marantz® SERVICE BULLETIN		Date: 15-May.-2003	Model: DR6000, DR6050, CDR631, CDR500
		Page: 1 / 1	REF.NBR: MZ02-031
Circulation:	Application:	Subject: Replace the Chip capacitor on the CDR module of MAR770/MAR775.	
x for information customer complaint in case of service mandatory	See Below		
		Int.ref:

marantz® SERVICE BULLETIN		Date: 22-Nov-01	Model: DR4050/DR6000/DR605 0CDR500/CDR631
		Page: 1/1	REF.NB MZ01-019
Circulation:		Application:	
x for information customer complaint in case of service mandatory		See below	
		Subject: Improvement for inoperable all buttons	
		Int.ref:

marantz® SERVICE BULLETIN		Date: 15-May.-2003	Model: DR6050,CDR500
		Page: 1 / 1	REF.NBR: MZ02-035
Circulation:		Application:	
x for information customer complaint in case of service mandatory		See Below	
		Subject: Miss clamp problem of CD single	
		Int.ref:

This is Pos.No.3114

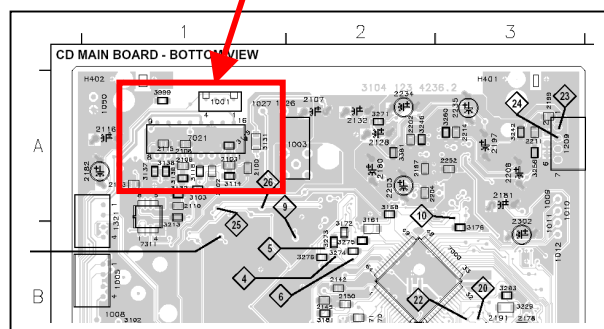
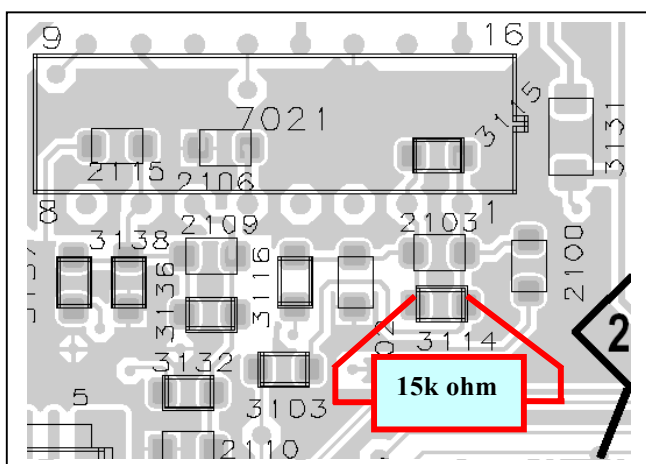
The OPEN/CLOSE movement of disc tray is fast, It may become a CD single [8cm(3in.)] clamp defect.

15k ohm resistor is soldered to the **Pos.No.3114** in parallel.

The object of PCB: CD MAIN BOARD of CD Module MAR1250
(Refer to the CDR500 service manual 2-13 page of MAR1250.)

15k ohm GD05153160
